PREPARED FOR THE PLAN COMMISSION

Project Address: 330 East Wilson Street
Application Type: Demolition Permit and Conditional Use
Legistar File ID #: [33909](#)
Prepared By: Heather Stouder, AICP, Planning Division
Report Includes Comments from other City Agencies, as noted

December 10 Revision

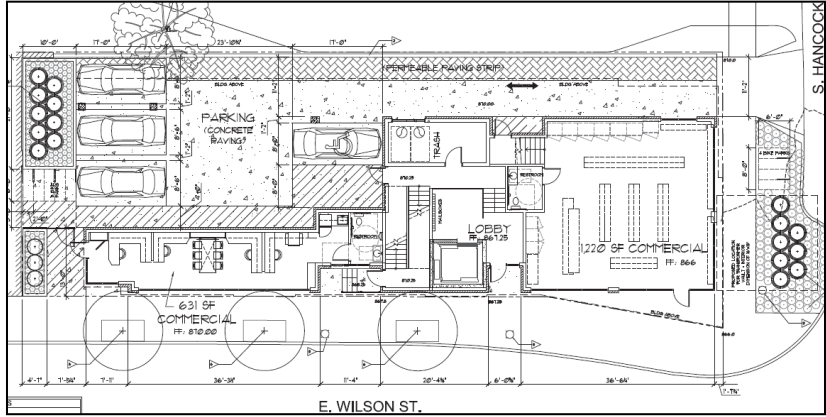
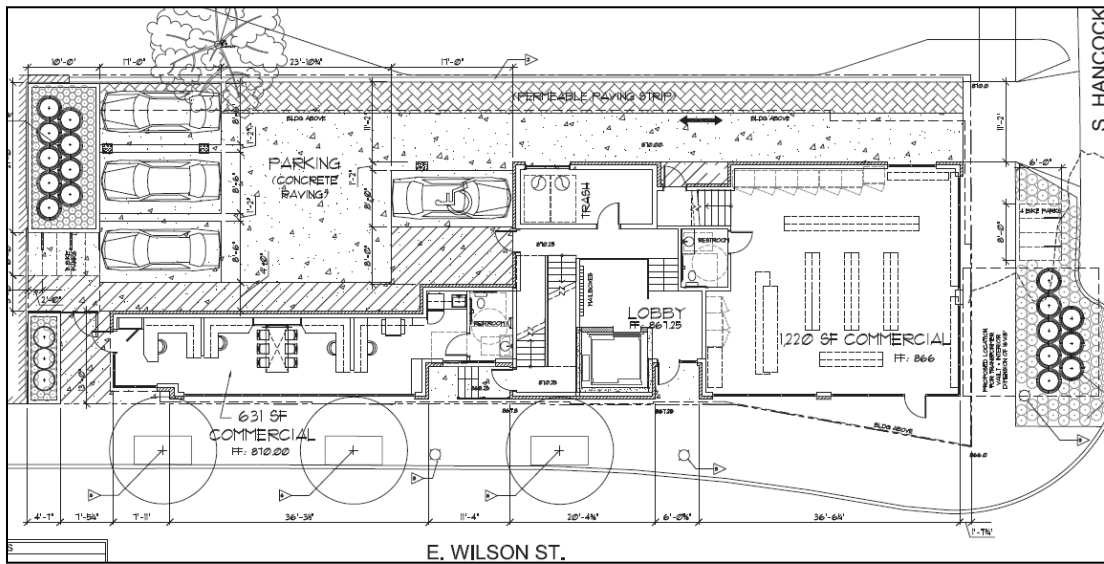
Building materials – The revised proposal is clad primarily in grey and tan standard-sized brick, with dark bronze metal as a secondary material. The grey brick is utilized on the base of the building, and also vertically on the northeast and southwest corners of the building.

Stair tower revisions – In the November 24 revisions, the stair tower was shown on the south facade as spandrel glass surrounded by a dark bronze metal frame, and was much narrower above the roofline than it had previously been. In the December 10 revision, the stair tower has been removed as an architectural element on the southern facade of the building. It is still narrower above the roofline than in previous versions.
